# Response to Public Comment on the Partial Delisting of Texas City from the Air Pollutant Watch List for the Air Toxics Benzene and Hydrogen Sulfide

## *Texas Commission on Environmental Quality Air Permits Division*

### October 2014

**Figure 1: Tanks Retrofitted with Benzene Controls**

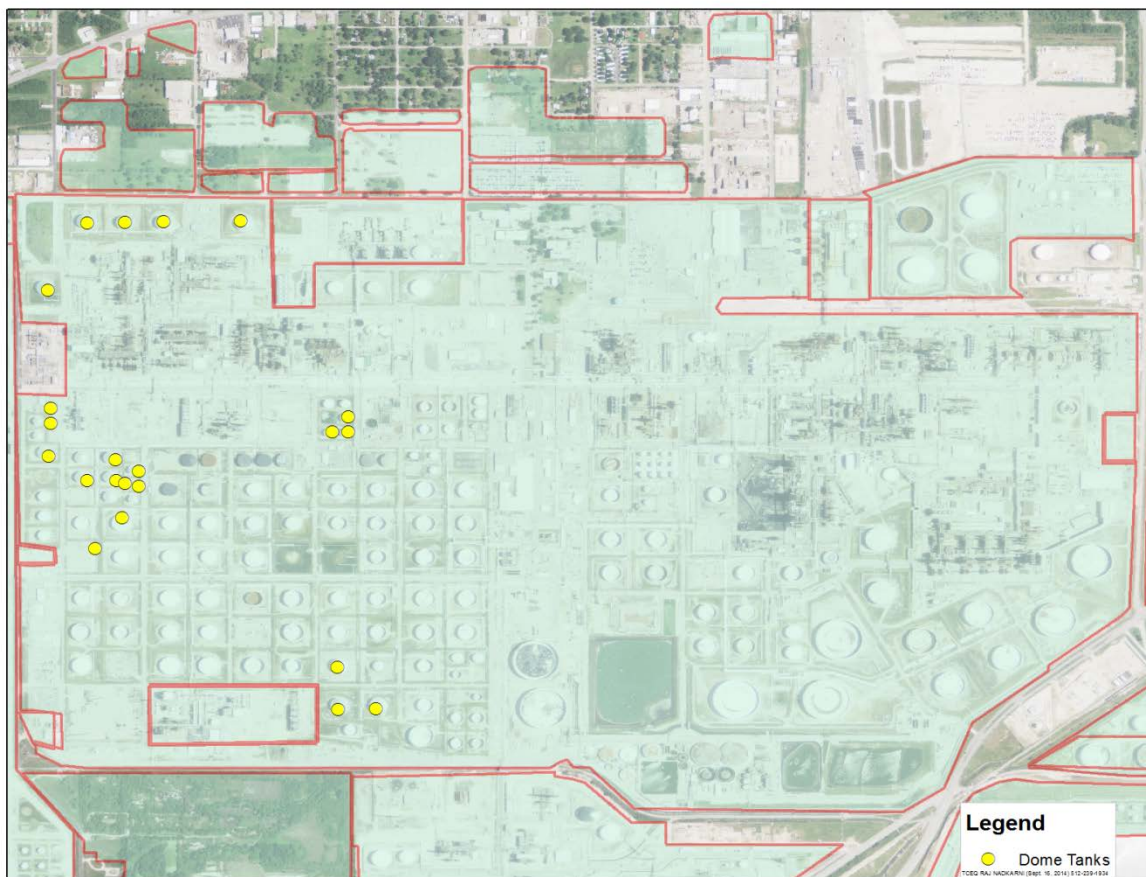
**Comment 25 regarding pinpointing the greatest benzene emission sources at the BP refinery:** AAH stated that they used wind directions to identify a tank farm in the western half of BP's facility as the source of the highest monitored concentrations of benzene at both the Logan Street and 31<sup>st</sup> Street monitors. AAH commented that the tank farm is a previously unrecognized source of benzene emissions. Also, the emissions from the tanks are consistent with several recent studies including the DIAL and EPA Other Test Method-10 studies that report that tanks are major VOC and benzene sources in refineries. AAH commented that, when prevailing winds place the Logan and 31<sup>st</sup> Street monitors downwind of the tanks, monitored concentrations of benzene spike. AAH also commented that measurements from days that prevailing winds put the existing monitors directly downwind of the pinpointed sources are diluted by averaging in measurements from days that the wind blows emissions away from the monitors.

**Response 25:** Benzene occurs naturally in gasoline, and other refinery products contain benzene. BP, like all refineries, has benzene sources. BP has reported benzene emissions from several of its facilities for many years. As discussed in the TCEQ's benzene delisting proposal, BP has already implemented several benzene control strategies at its refinery through the TCEQ/EPA enforcement process, including the installation of additional controls on 22 tanks. The following figure shows the tanks that have the additional controls, shown as yellow circles. The figure illustrates that controls have been installed on tanks located in the western portion of the refinery.

In addition, siting of the monitor is only one of many variables that could explain lower concentrations of benzene observed at the 31<sup>st</sup> Street monitor as compared to the Logan Street monitor. It is likely that improvements made by industry are causing the lower benzene concentration detected by the 31<sup>st</sup> Street monitor. One such improvement is the retrofit of tanks with additional controls. These tanks are pictured in the upper left corner of Figure 1.

**Figure 5: Locations of Texas City Monitors**

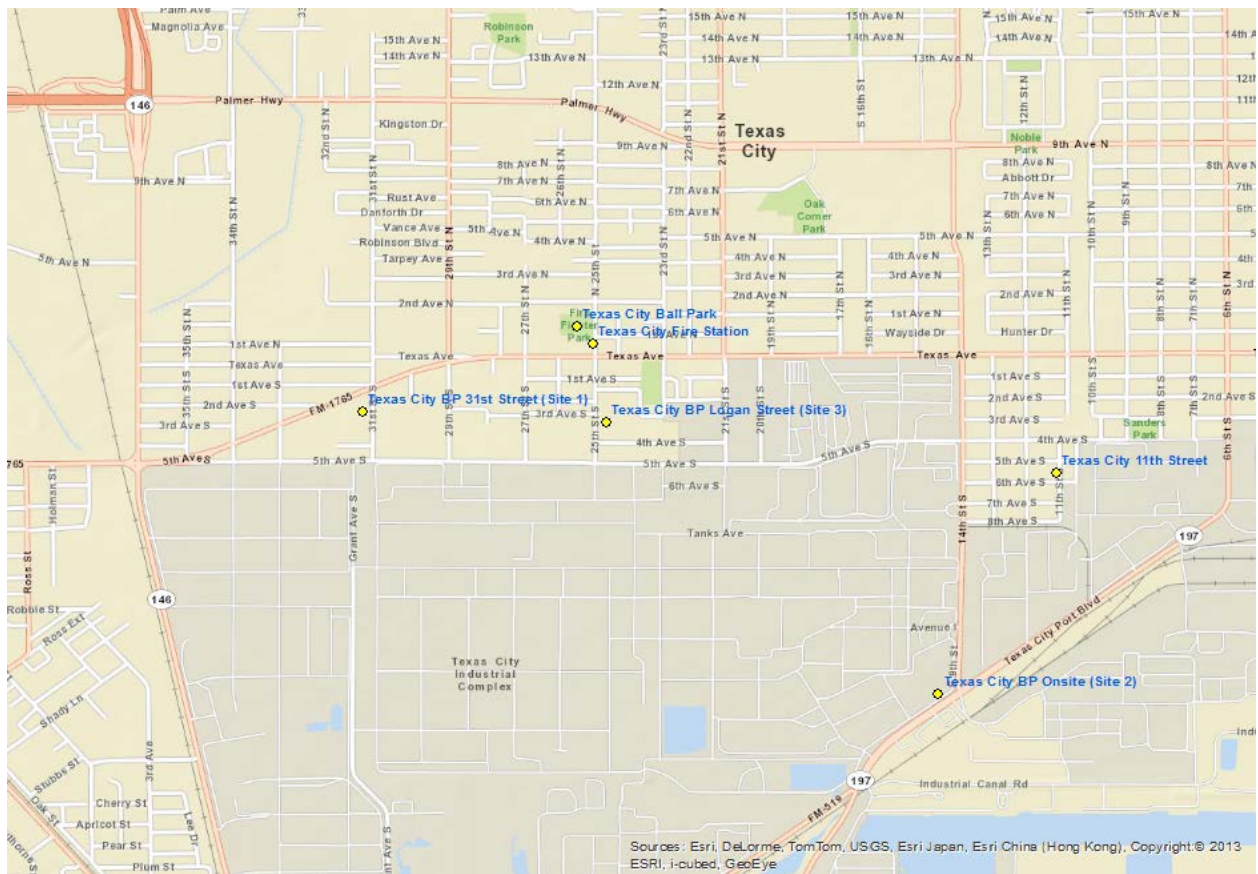
**Comment 26 regarding the location of monitors:** AAH commented that the annual average benzene concentration is artificially low without a properly sited monitor. AAH commented that BP's 31<sup>st</sup> Street monitor is north of the primary source of emissions within the western half of the BP facility, and it is surrounded by trees to the south directly in the path of the facility, which could affect its accuracy. AAH commented that the poor siting of the 31<sup>st</sup> Street monitor impacts the data collected at that monitor. AAH commented that the 31<sup>st</sup> Street monitor should not be used to monitor compliance with the long-term AMCV. AAH commented that the poor placement of the 31<sup>st</sup> Street monitor is indicative of poor planning and execution of the monitoring plan in Texas City.

**Comment 31 regarding the lack of monitors in the residential area downwind from the refinery:** AAH noted that a residential community is located downwind of the benzene sources in the western part of the refinery, but there are no official TCEQ canister-based monitoring stations situated within this downwind community to intercept benzene plumes.

**Response 26:** The TCEQ ensures that the siting criteria guidelines for ambient monitors specified in Title 40 Code of Federal Regulations Part 58 (Part 58) are followed when monitors are put into place. Appendix E to Part 58 states that trees can act as obstructions in cases where they are located between the air pollutant sources and the monitoring site and where the trees are of a sufficient height and leaf canopy density to interfere with the normal airflow around the probe, inlet, or monitoring path. Further, Appendix E requires that the probe, inlet, or at least 90 percent of the monitoring path be at least 10 meters or further from the drip line of trees to reduce possible interference/obstruction from trees. AAH submitted aerial images that show the presence of vegetation between the monitor and the BP site. Because an area may change over time after a monitor has been installed, the TCEQ conducted further analysis regarding the siting of this monitor to address these comments. After reviewing the site, the TCEQ took the following photograph in July 2013. The vegetation between BP and the monitor is shown on the left side of the monitor in the picture.

**Response 31:** The TCEQ has determined that it is not necessary to deploy monitors along the company's entire fence line. BP operates two monitors that are downwind of its site from the predominant wind direction, and these monitors are less than three quarters of a mile apart. AAH used the data from BP's two monitors to conduct its own source determination and evaluation, thus demonstrating the effectiveness of this monitoring configuration.
